PLANNING COMMISSION STAFF REPORT

AGENDA ITEM: Planning File No. MAJ-25-0003: A sketch plan review of a remodel to a commercial property consisting of a fast food restaurant located at 960 N. Ten Mile Drive.

LOCATION: 960 N. Ten Mile Drive / LOT R1 BLOCK 1 LAKEPOINT AT FRISCO SUB RESUB L2 BLK1 AMENDED

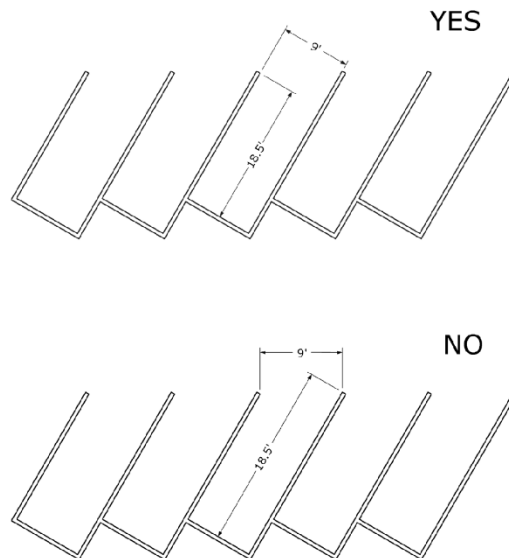
The application currently shows parking spaces measuring 9 feet by 18 feet. The proposed parking layout does not appear to meet the parking design standards due to the parking space dimensions. The application shall be in full compliance at the full Major Site Plan application review. The application meets the requirements for drive aisles and accessibility aisles.

Figure 5: Proposed Landscaping

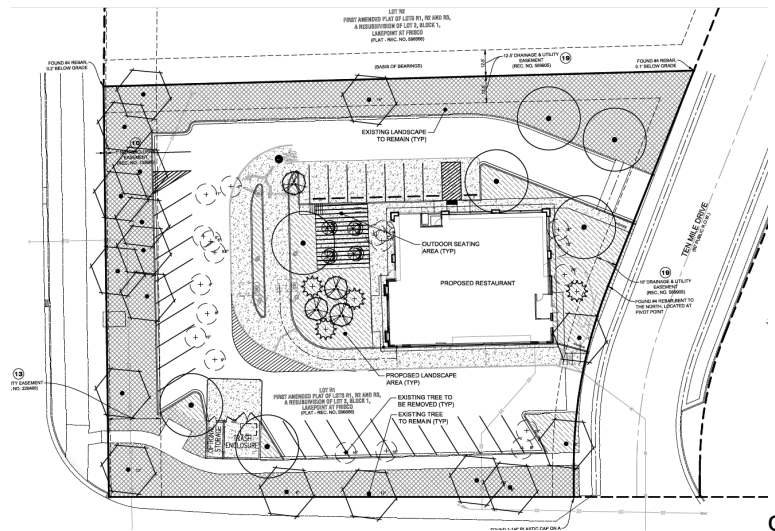
The application shows 1,255 sf of landscaping within 10 feet of the parking area, including the 8 required trees. Staff requests that Planning Commission comment on whether the applicant is meeting the requirement for internal parking lot landscaping.

Figure 7: Proposed landscaping abutting building

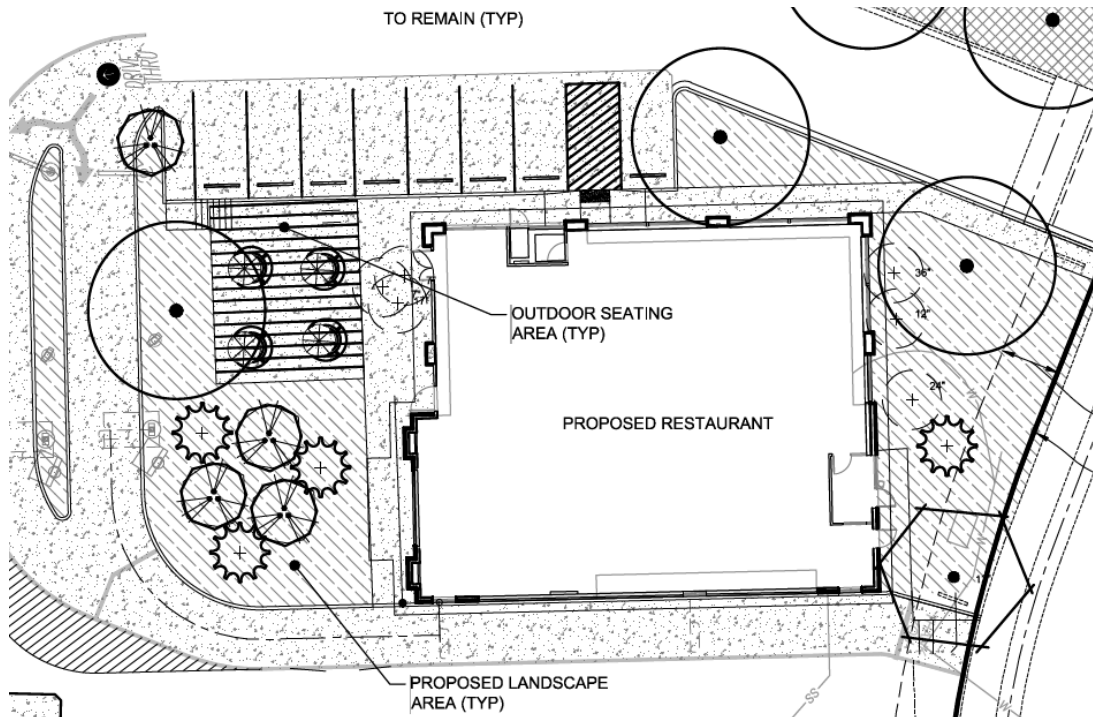
Parking lots or paving abutting a building shall provide a landscaped area of 5-10 feet in width, with half of the area being 10 feet in width and the area running along 50% of the building. If less than 50% of the required parking spaces are in the front of the building, the landscape buffer may be reduced to 35% of the length of the building, with Planning Commission approval. The application materials show a landscape buffer on the east façade of the building, but the north, south, and west sides of the building directly abut paving. The existing building includes landscape buffers adjacent to the building. While a landscape buffer on the drive-through south side of the building may not be feasible, a landscape buffer meeting these requirements will be required on the west and north sides of the building. The parking layout qualifies for a reduction in the required landscape buffer to 35% of the building if approved by Planning Commission. Staff requests that Planning Commission comment on the landscape buffers around the building.
